**Re: Defect Information Report (FL-430), NHTSA no. 04V-401  
Condor Steering Gear Mounting Bolts**

**Section 573.6 Defect Information Report**  
**FL-430, NHTSA no. 04V-401**  
**Supplement No.: 1**

**Revision: Step 14 of the work instructions has an updated torque value.**

March 2005  
FL430AB  
NHTSA #04V-401  
SECOND REVISED NOTICE

Fig. 1, Dual Steering Gear Mounting Bracket Assemblies (LH/RH Drive similar)

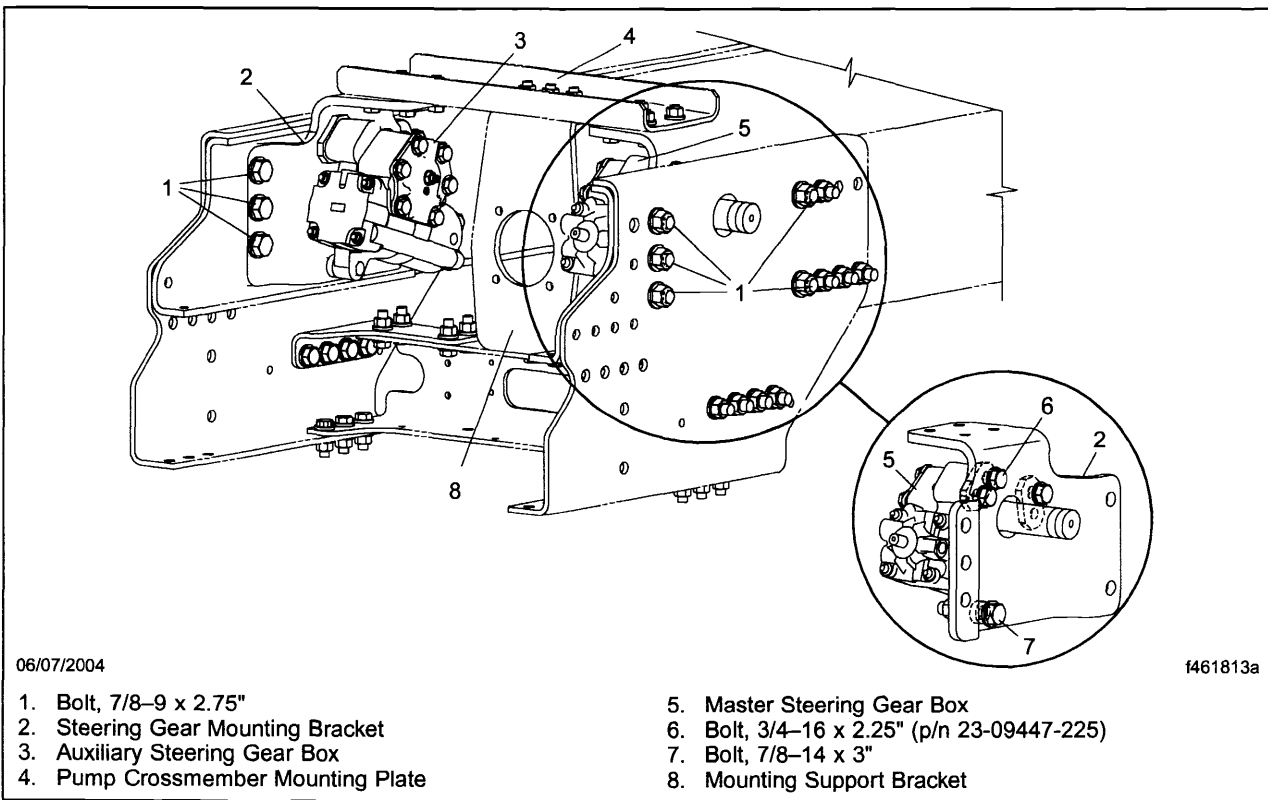
NOTE: The following procedures are the same for the left-hand-drive and right-hand-drive vehicles. On dual-gear vehicles, these procedures will apply to both gear boxes. Use replacement steering gear mounting bolts (p/n 23-09447-225 from kit 25-FL430-000); see Fig. 1, Ref. 6.

**Fig. 3, Steering Gear Mounting Bracket (view of frame removed for clarity)**

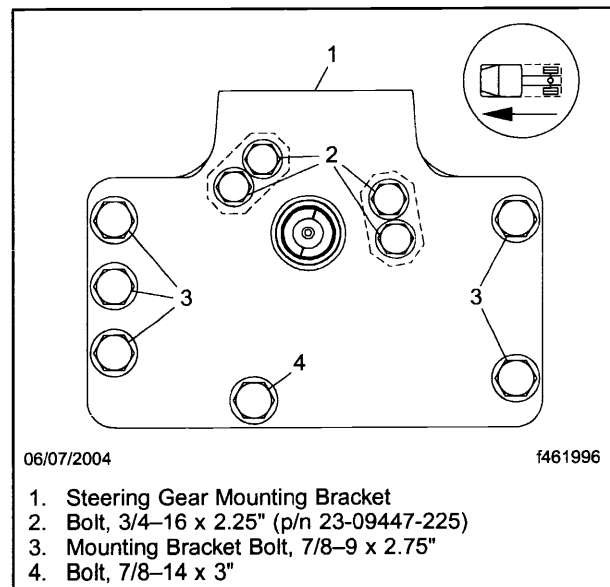
**Revision:** Step 14 of the work instructions has an updated torque value.

13. Allow the steering gear to lean toward the middle to gain access to the bolts. If the truck has a front mount PTO, lean the gear against the PTO.
14. Using the 3/4–16 x 2-1/4 bolts supplied with the kit, replace each bolt (one at a time) that attaches the steering gear mounting bracket to the steering gear. There will be four on each gear. Tighten the bolts to 269 lbf-ft (365 N·m). See **Fig. 3**
